802.3at: Select Issues

Figure 33-18: P_{class_PD}

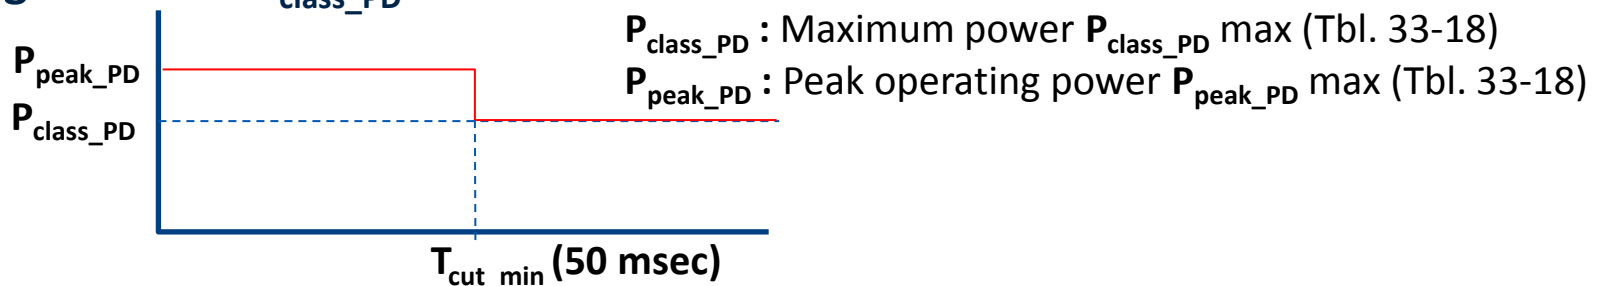
ISSUE: What if LLDP defines $P_{class_PD} \max$ (power grant)?

P_{peak_PD} and P_{class_PD} in Figure 33-18 cannot be $P_{class_PD} \max$, $P_{peak_PD} \max$ from Table 33-18

Clause 79.3.2.1 - .3 Power Via MDI

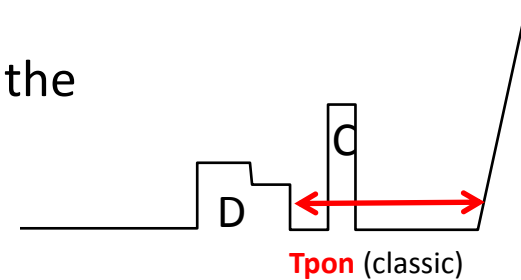
ISSUE: Relevance and Content of Power Via MDI TLV's

- ❑ Information extraneous to 802.3at LLDP power negotiation – that only needs the “Extended” content
- ❑ Many LLDP PSE's don't appear to populate these correctly today (e.g. PSE MDI Power Support = NONE)

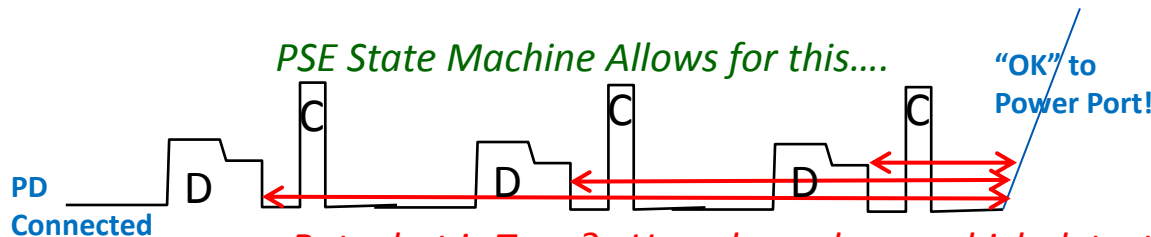
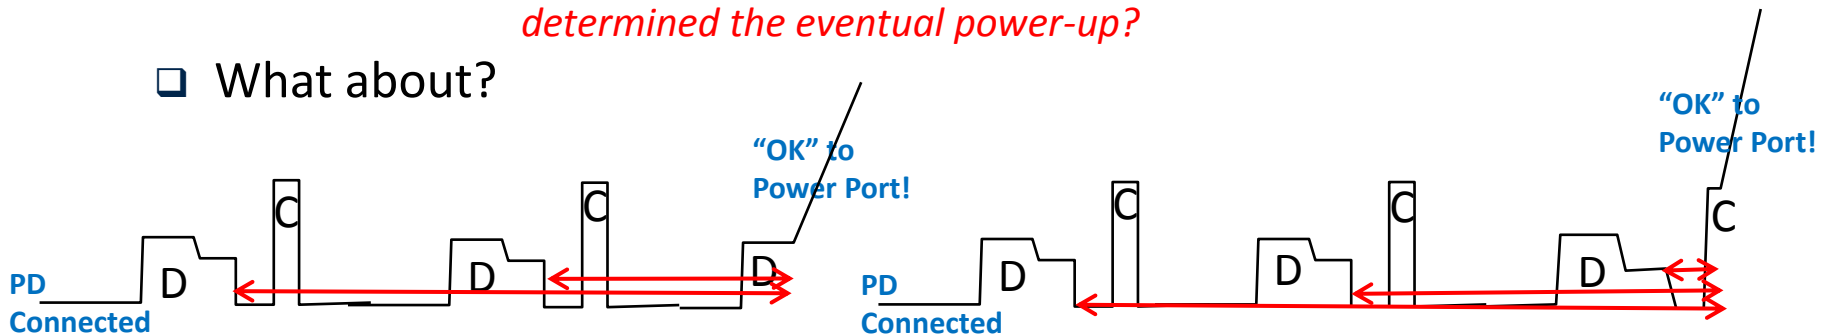
But what is Tpon? How do we know which detection measurement determined the eventual power-up?

- What about?

Para. 33.2.7.6 Overload Current

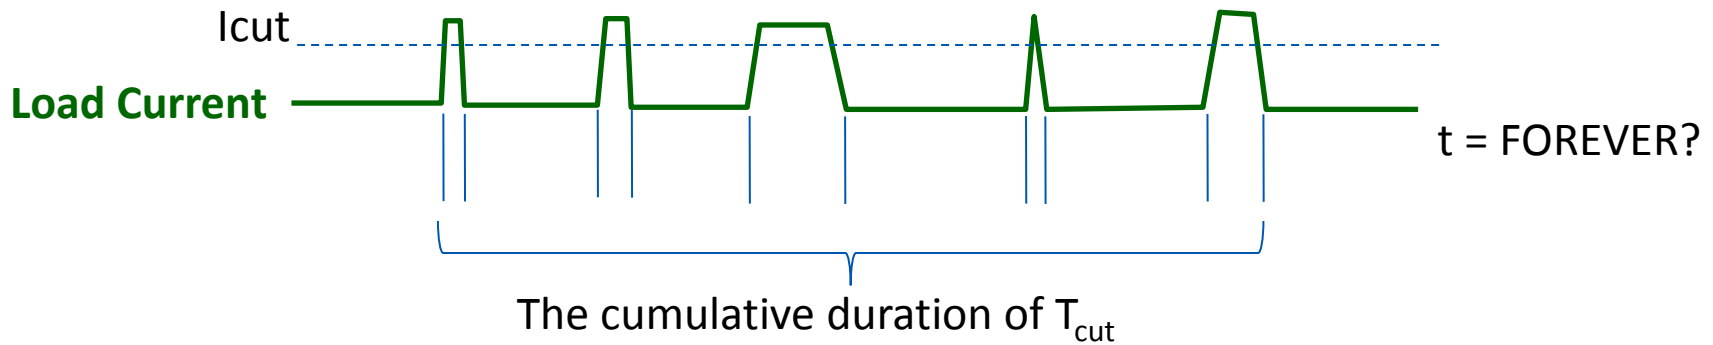
ISSUE: What is a Violation of I_{cut}/T_{cut}?
